# Rezoning Transportation Analysis

Petition Number: 2025-058

General Location Identifier: 08702225, 08702224

Date	Description
07-22-25	First Review (ME)
11-20-25	Second Review (ME)
04-23-26	Third Review (ME)

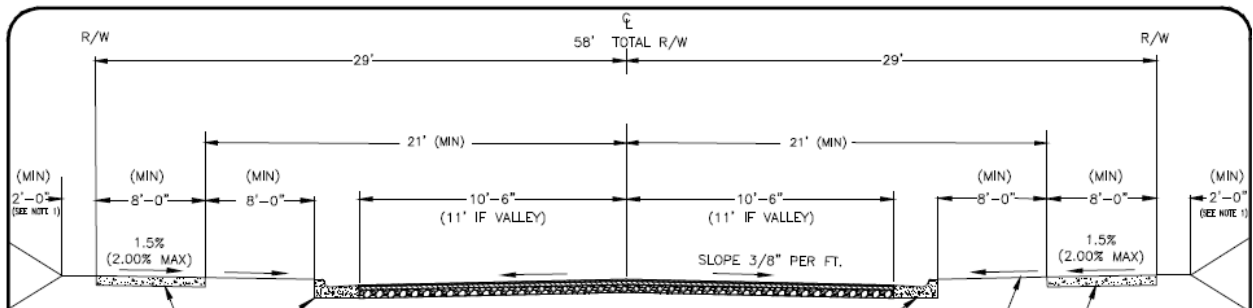
- a. **Hondures Drive:** Location of curb and gutter to be installed to 17.5 feet from the roadway centerline to accommodate CLDSM U-03A1 with a roadway typical section of a residential wide street.

**Outstanding Comment from 11/20/25:** Show curb and gutter along Hondures Drive as 2.5 foot curb and gutter with a 15 foot travel lane following CLDSM U-03A1 and to maintain uniformity with the existing curb and gutter type along Hondures Drive.

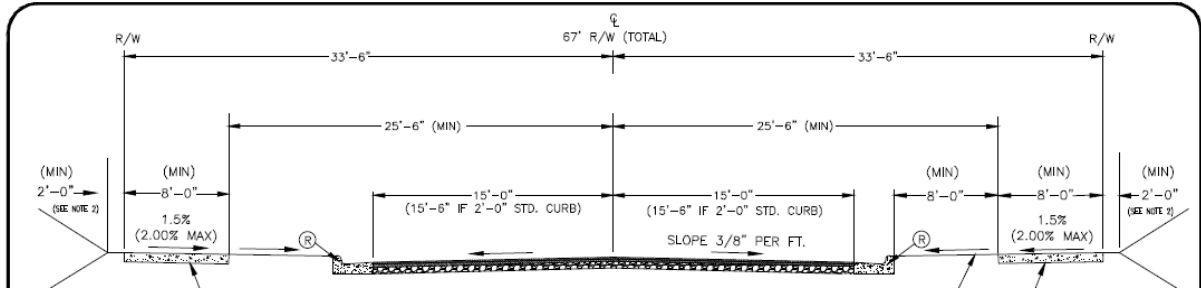
Label and dimension the curb and gutter from the centerline for each road on the site plan.

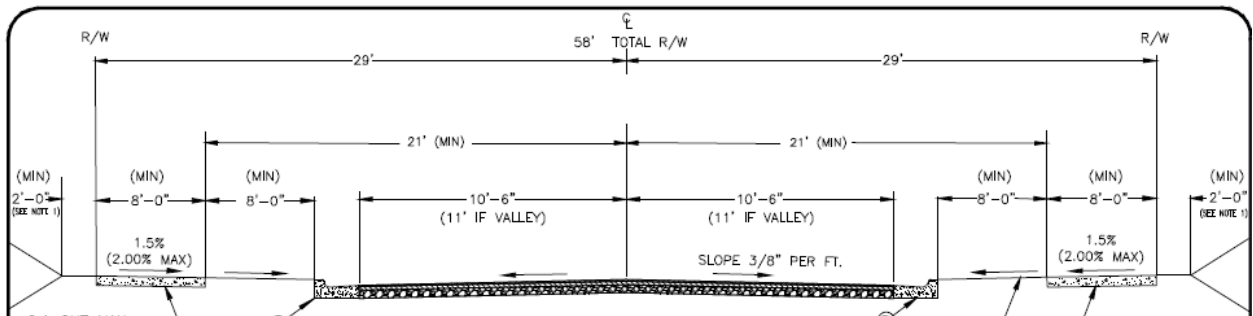
3. Revise site plan and conditional note(s) to commit to dedicate 33.5 feet right-of-way from the road centerline for Hondures Drive and internal public roads. The site plan shall label and dimension the right-of-way from the road centerline.

**Outstanding Comment from 11/20/25:** Provide conditional notes committing to dedicate 33.5 feet right-of-way from the road centerline for Hondures Drive and 62-foot right-of-way for the extension of Anna Garrison Road. Change label of "NEW ROW" in site plan to "PROPOSED ROW". Remove the proposed ROW across Anna Garrison Road circled below. The proposed ROW for Hondures Drive should meet the proposed ROW for the Anna Garrison Road extension at the intersection corners. Show a similar line type for the proposed ROW on Anna Garrison Road extension as shown for Hondures Drive.
